Model: Katana		Date:14-Jul-06	No.: RB234015
Subject: Service Manual Revision		Prepared by: S. Ishizu	
From: 2nd Tech Support Sec. Service Support Dept.			
Classification:	<input type="checkbox"/> Troubleshooting <input type="checkbox"/> Mechanical <input type="checkbox"/> Paper path <input type="checkbox"/> Product Safety	<input type="checkbox"/> Part information <input type="checkbox"/> Electrical <input type="checkbox"/> Transmit/receive <input type="checkbox"/> Other ()	<input type="checkbox"/> Action required <input checked="" type="checkbox"/> Service manual revision <input type="checkbox"/> Retrofit information

This document summarizes the corrections in the Service Manual for “Katana” (Machine Code: B234/235/236).

3. Corrected PM table <Page: 2-8>

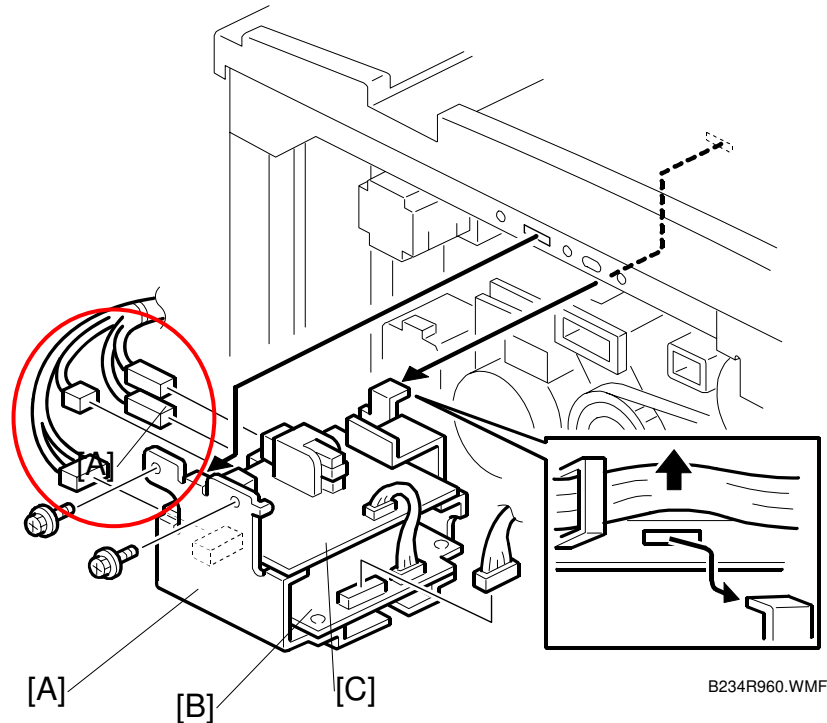
Hot roller gears	C/L			Lubricate (Barrierta 55L or SS552R)
------------------	-----	--	--	-------------------------------------

Correct

Hot roller gears	C/L			Lubricate with <u>Grease Barrierta – JFE5 5/2 (A2579300)</u>
------------------	-----	--	--	---

1.EXTERIOR (B834)

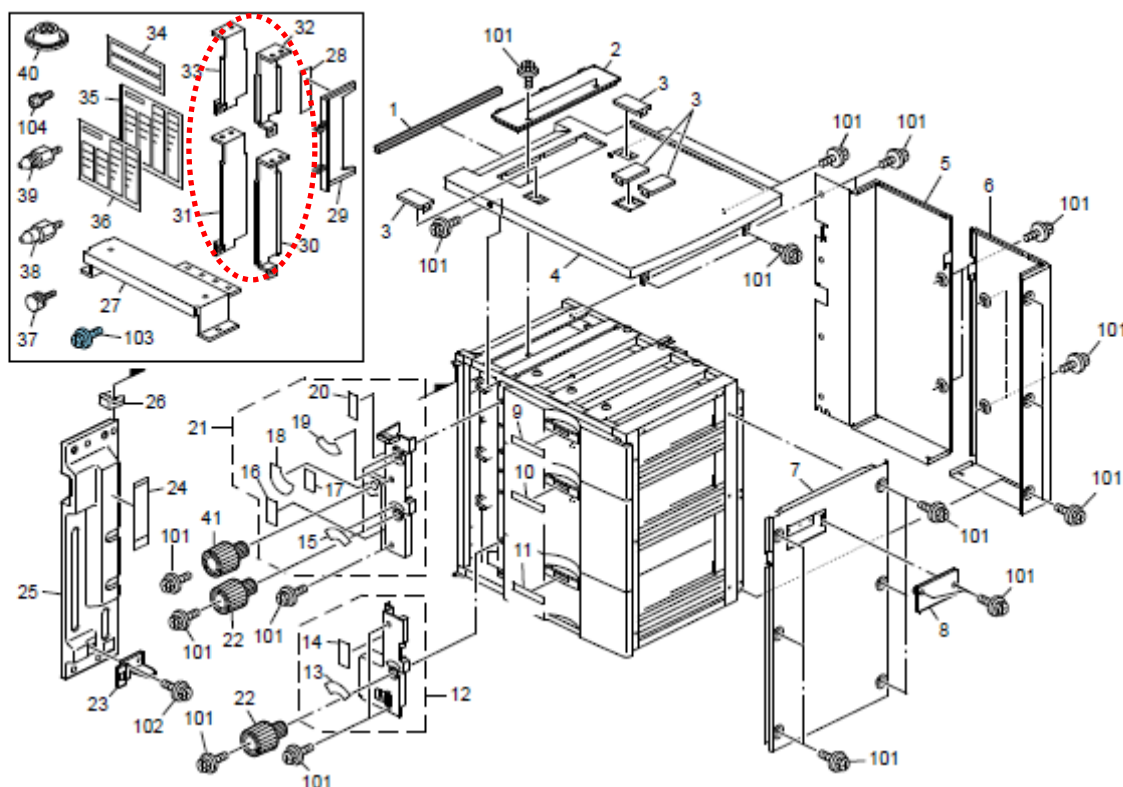
Change: Shape of the postcard fence

Old Part Number	New Part Number	Description	Q'ty	Int	Page	Index	Note
B8342713	B8342717	BRACKET:POSTCARD:NO.1: REAR:ADHESION	1	O/O	as a set	3	33
B8342711	B8342719	BRACKET:POSTCARD:NO.2: REAR:ADHESION	1	O/O		3	31

3.4TH/6TH PAPER TRAY 2 (B834)

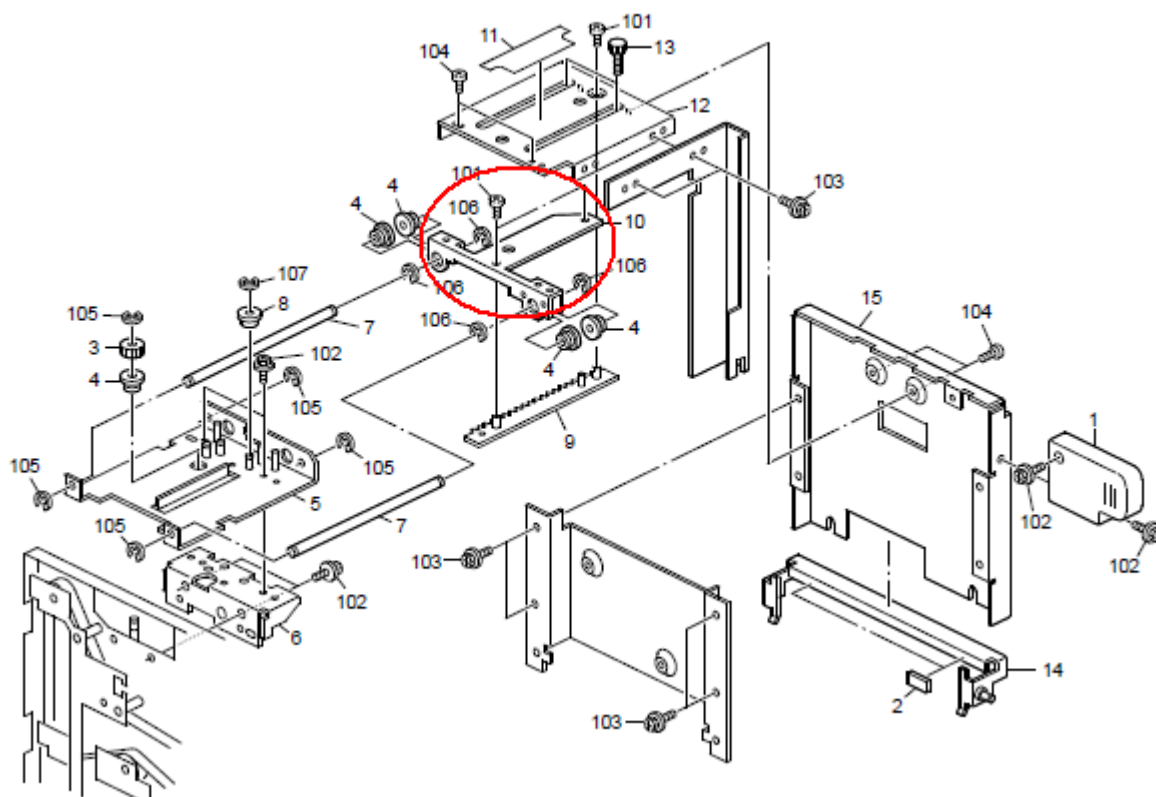
This RTB has been issued to announce that some parts for the LCIT have been changed

Old part number	New part number	Description	Q'ty	Int	Page	Index	Note
B8343332	B8343341	GUIDE:UPPER FRONT	1	x/x	7	10	B834
B8343334	B8343343	GUIDE:UPPER REAR	1	x/x	9	14	B834
B8343339	B8343345	RACK:UPPER	1	x/x	21	9	B834
B8343349	B8343345	RACK:UPPER	1	x/x	23	16	B834
D3553332	D3553334	GUIDE:LM-6:UPPER FRONT:PEEN	1	x/x	9	10	D355

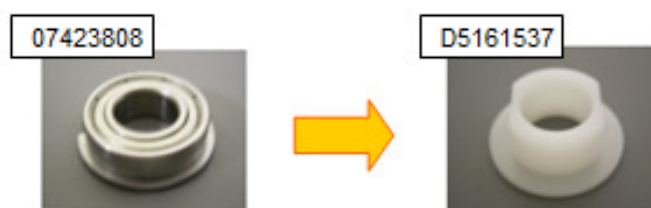
Change: Bearing and the shape of the accompanying plates

1, The bearing was changed as shown in the photo below.

2, The size of the holes on the plates were reduced to correspond with the modified bearings.

2.Tray 4/6 Unit 1 (D453)

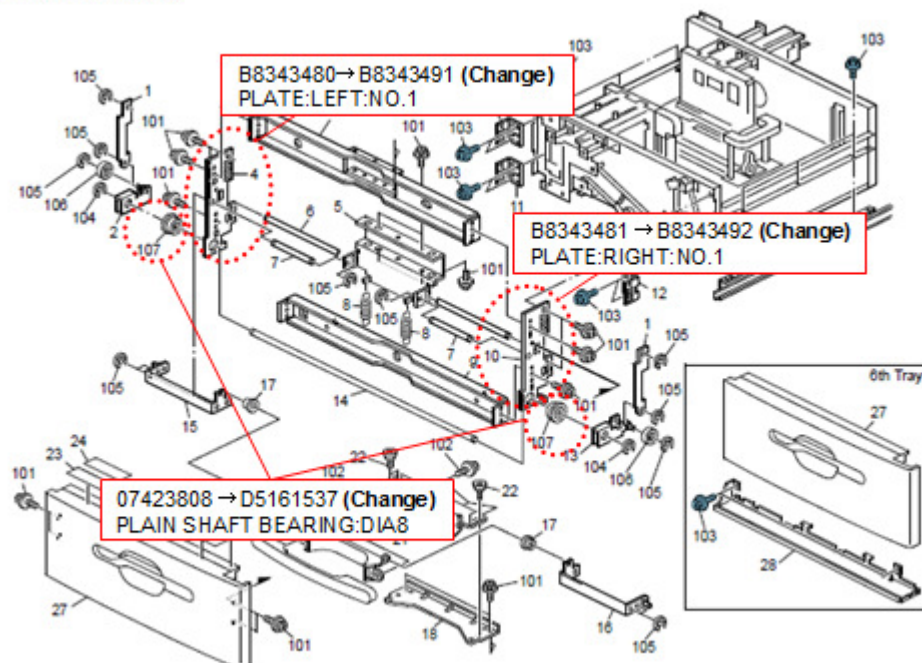
Old Part Number	New Part Number	Description	Q'ty	Int	Page	Index	Note
07423808	D5161537	PLAIN SHAFT BEARING:DIA8	4	X/O	4 18	107 105	
B8343395	B8343391	PLATE:LEFT:NO.2	1	X/O	18	3	
B8343396	B8343392	PLATE:RIGHT:NO.2	1	X/O	18	11	
B8343480	B8343491	PLATE:LEFT:NO.1	1	X/O	4	4	
B8343481	B8343492	PLATE:RIGHT:NO.1	1	X/O	4	10

- Make sure all 5 parts shown in the above table are replaced as a set.
- The modification described in this bulletin also applies to RT5010 (B834).

3.4TH/6TH PAPER TRAY 2 (B834)

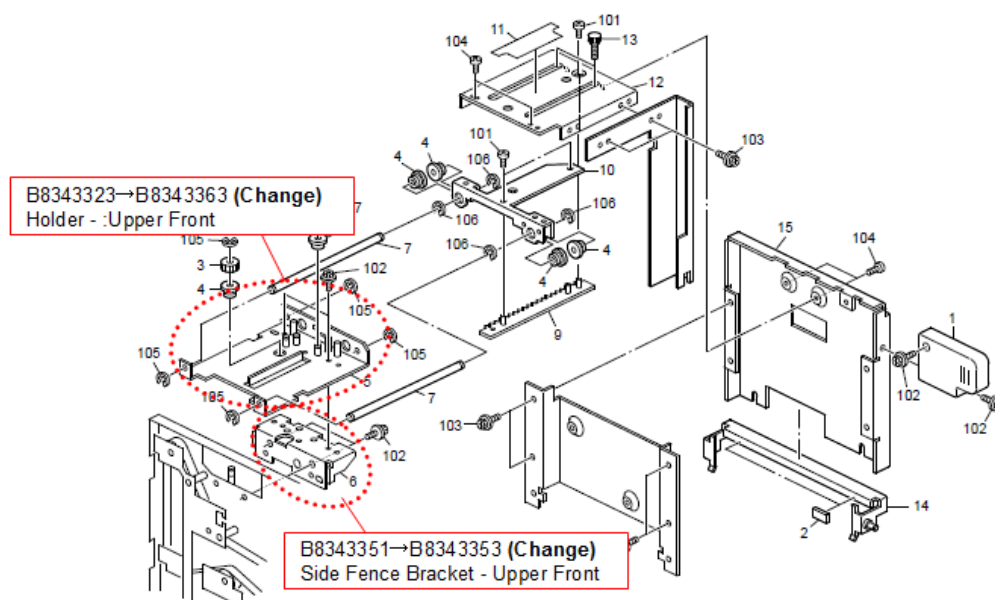
Old Part Number	New Part Number	Description	Q'ty	Int	Page	Index	Note
B8343323	B8343363	Holder - :Upper Front	1	X/X	7	5	A
B8343329	B8343364	Holder - Upper Rear	1	X/X	9	21	A
B8343351	B8343353	Side Fence Bracket - Upper Front	1	X/O	7	6	A
B8343352	B8343354	Side Fence Bracket - Upper Rear	1	X/O	9	19	A

- **When replacing the above parts, replace all 4 parts as a set.**
- **The modification described in this bulletin also applies to Aegis-C1 (D016), LCIT RT4000 (D350), LCIT RT5020 (D355), LCIT RT5040 (D453).**
